CDOT Comments for trail connection between Church St-Mint St:
Width/Typical Section:
16' width as measured in AutoCAD site file is appropriate. Follow CLDSM Standard 10.42 for typical section.

HILL ST. EXHIBIT

Conceptual Design for Developer Agreement
3 April 2019

**620 SOUTH TRYON STREET
MIXED-USE DEVELOPMENT**
LINCOLN HARRIS - CHARLOTTE, NC

NOT TO SCALE
CITY OF CHARLOTTE
DEPARTMENT OF TRANSPORTATION
OFF-STREET
MULTI-USE PATH
PAVEMENT MARKINGS
11/16/18 | REVISED 10-2018 | SHEET 1 OF 4

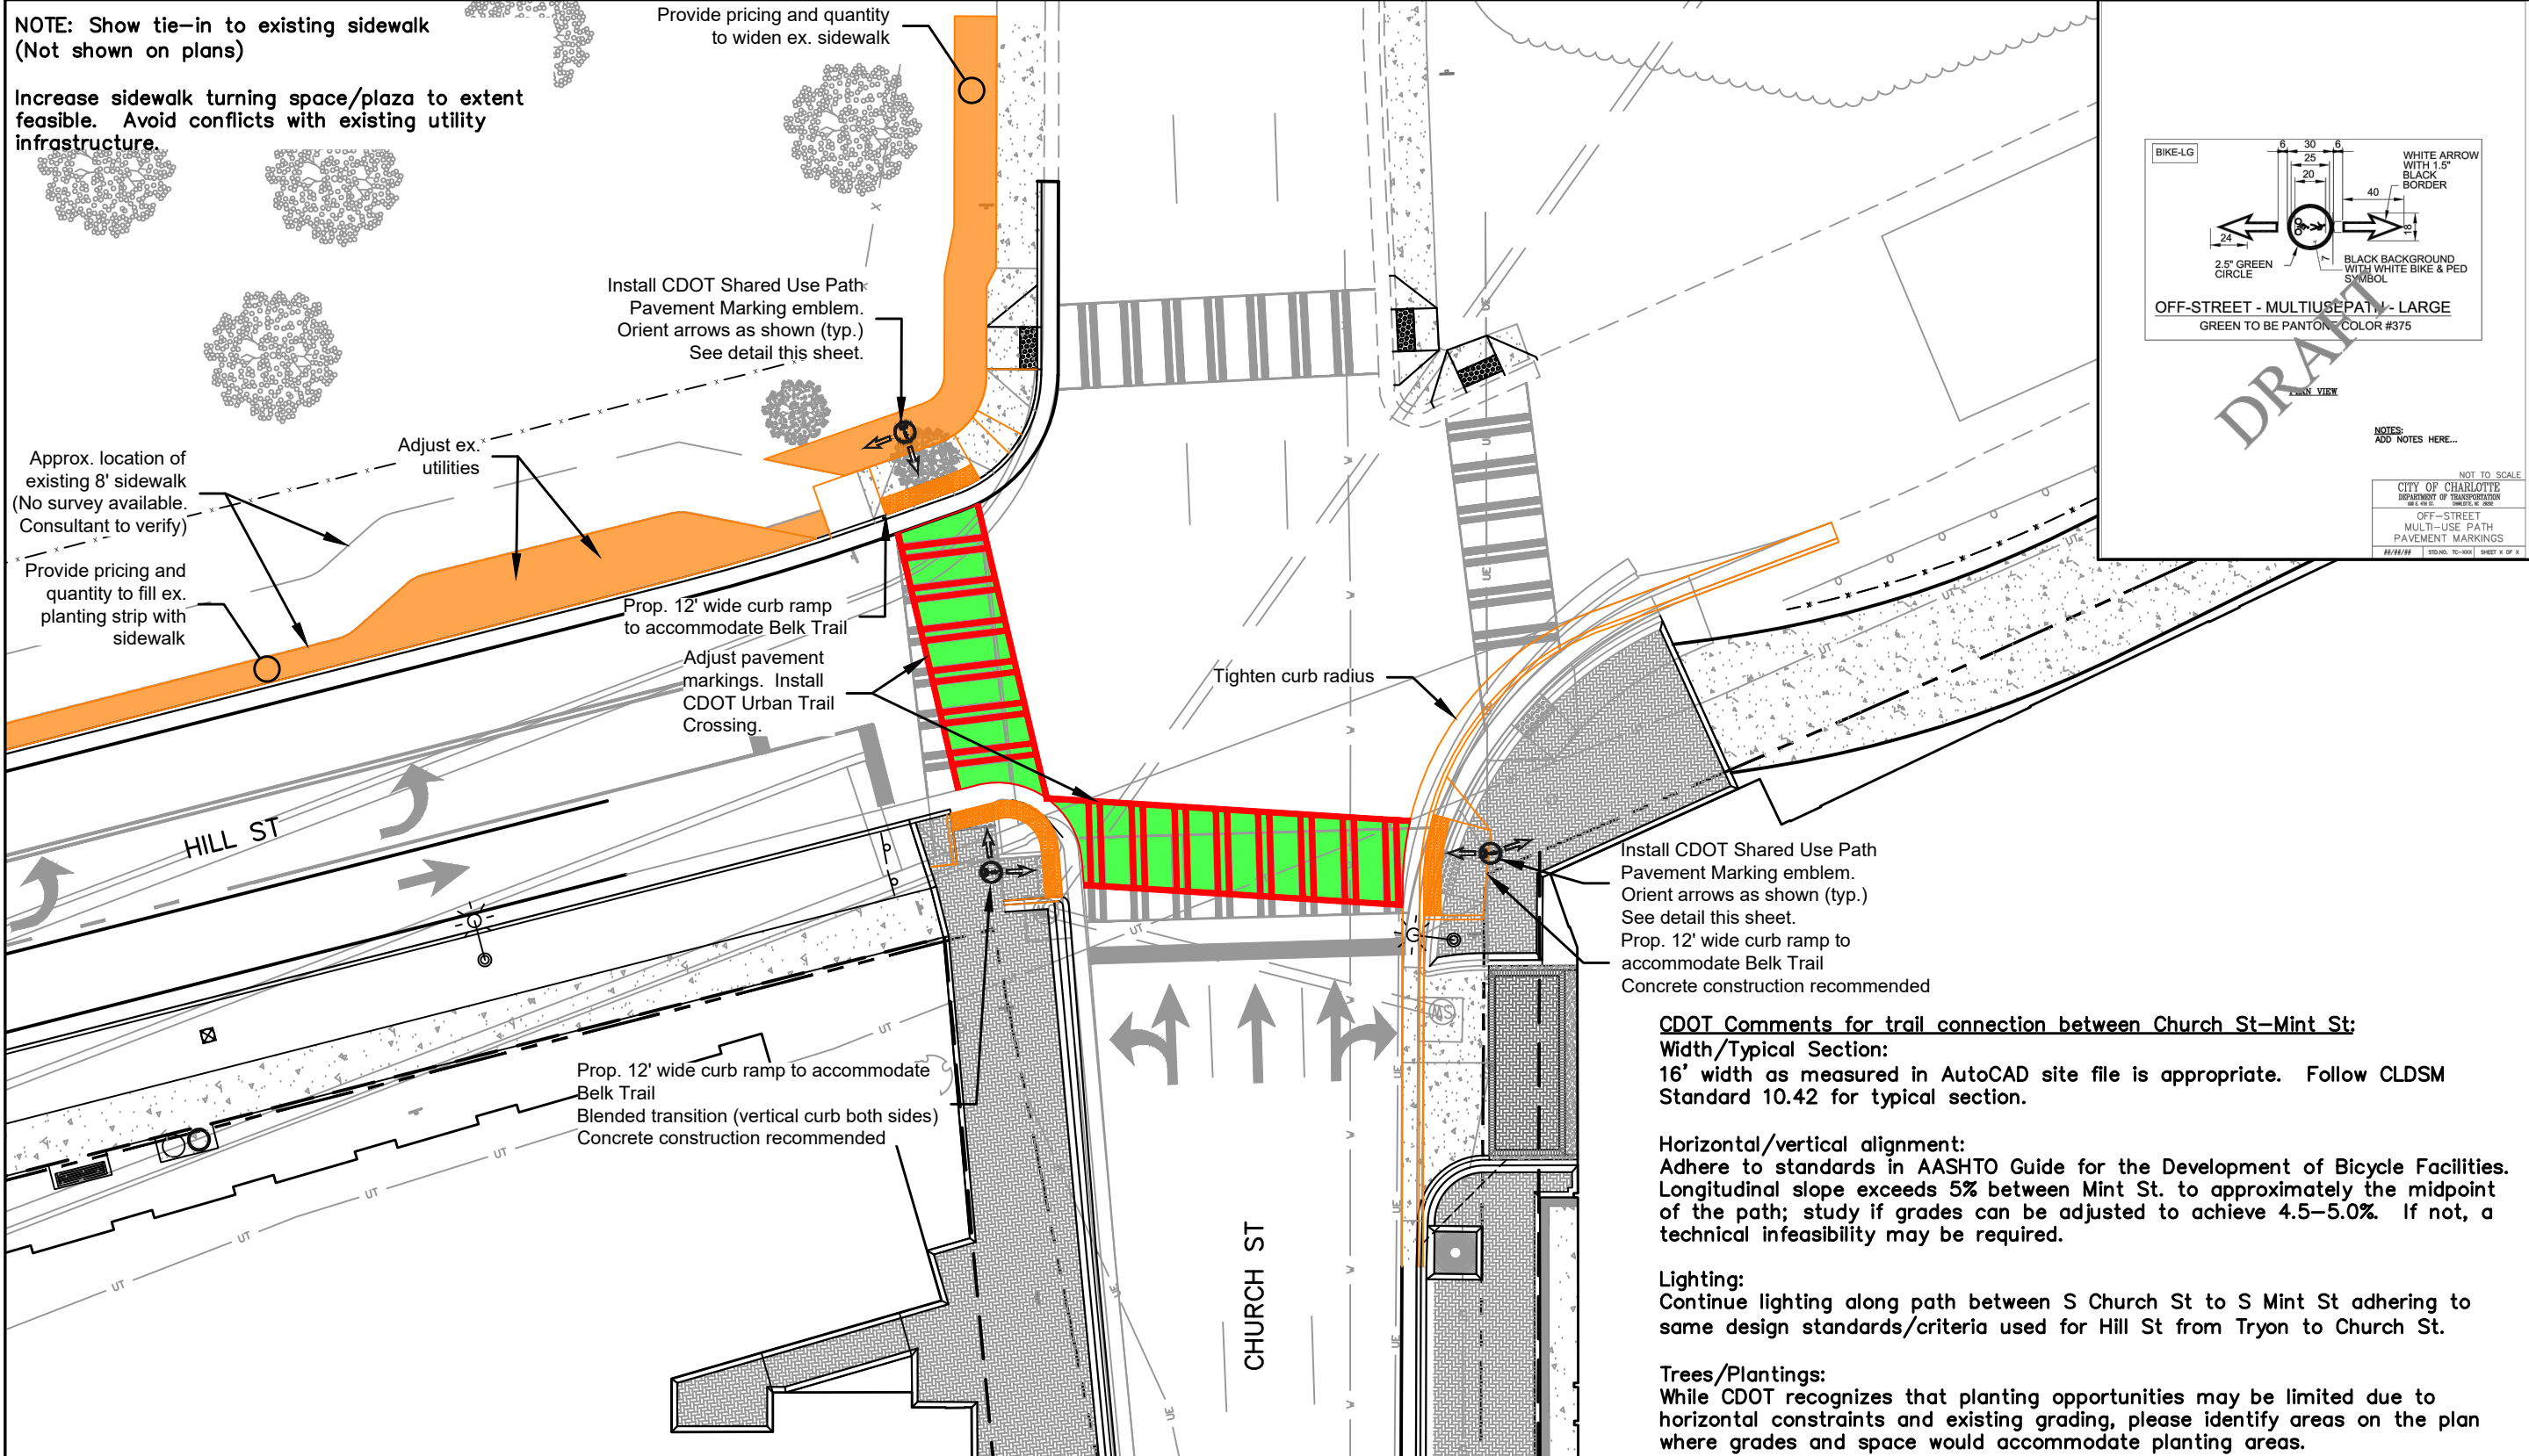
Install CDOT Shared Use Path Pavement Marking emblem. Orient arrows as shown (typ.) See detail this sheet.

Install CDOT Shared Use Path Pavement Marking emblem. Orient arrows as shown (typ.) See detail this sheet.
Prop. 12' wide curb ramp to accommodate Belk Trail
Concrete construction recommended

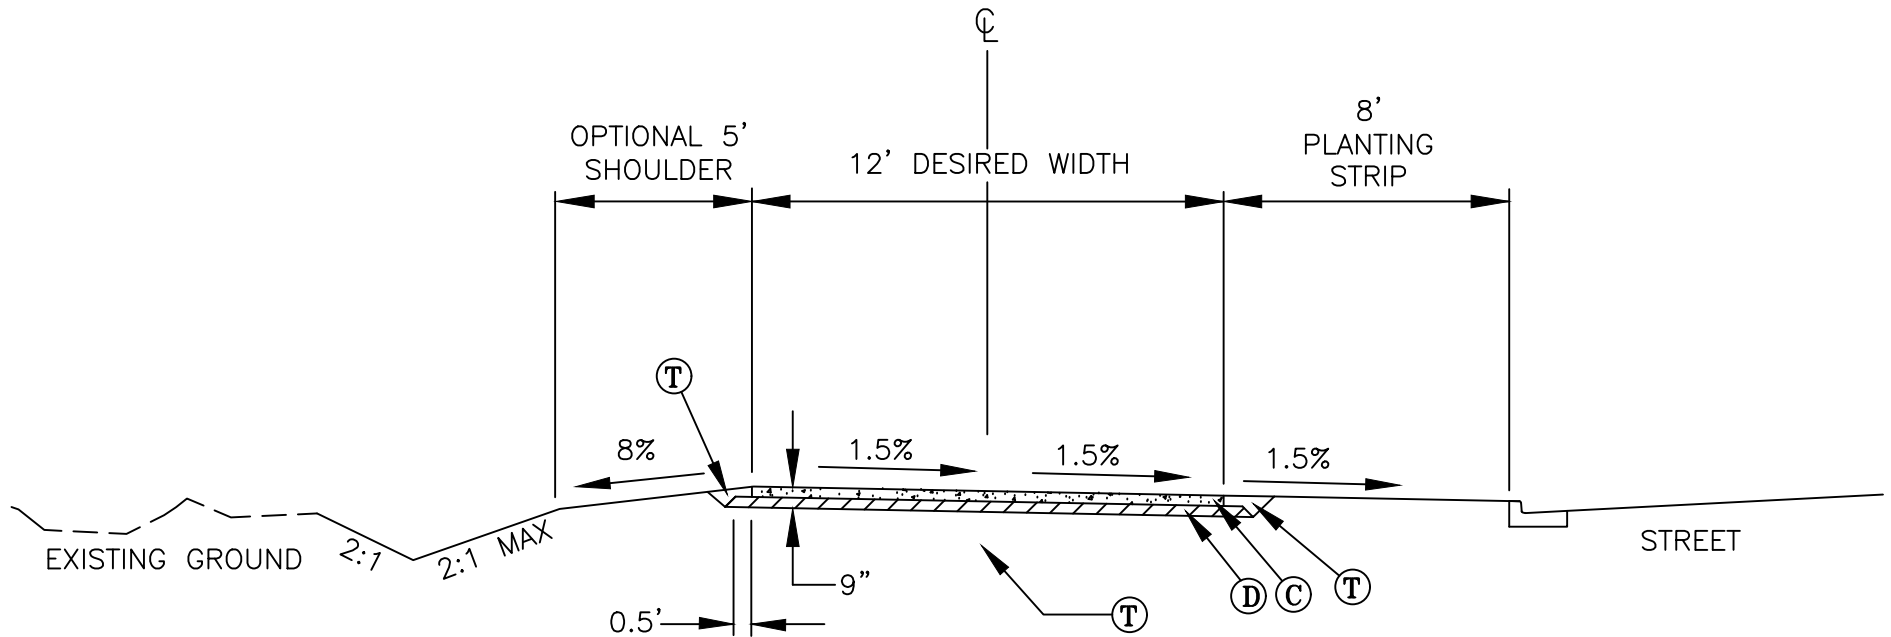
NOTE: Show tie-in to existing sidewalk
(Not shown on plans)

Increase sidewalk turning space/plaza to extent feasible. Avoid conflicts with existing utility infrastructure.

Provide pricing and quantity to widen ex. sidewalk

Approx. location of existing 8' sidewalk (No survey available. Consultant to verify)

Adjust ex. utilities

Provide pricing and quantity to fill ex. planting strip with sidewalk

Prop. 12' wide curb ramp to accommodate Belk Trail

Adjust pavement markings. Install CDOT Urban Trail Crossing.

Tighten curb radius

Prop. 12' wide curb ramp to accommodate Belk Trail
Blended transition (vertical curb both sides)
Concrete construction recommended

Horizontal/vertical alignment:
Adhere to standards in AASHTO Guide for the Development of Bicycle Facilities. Longitudinal slope exceeds 5% between Mint St. to approximately the midpoint of the path; study if grades can be adjusted to achieve 4.5-5.0%. If not, a technical infeasibility may be required.

Lighting:
Continue lighting along path between S Church St to S Mint St adhering to same design standards/criteria used for Hill St from Tryon to Church St.

Trees/Plantings:
While CDOT recognizes that planting opportunities may be limited due to horizontal constraints and existing grading, please identify areas on the plan where grades and space would accommodate planting areas.
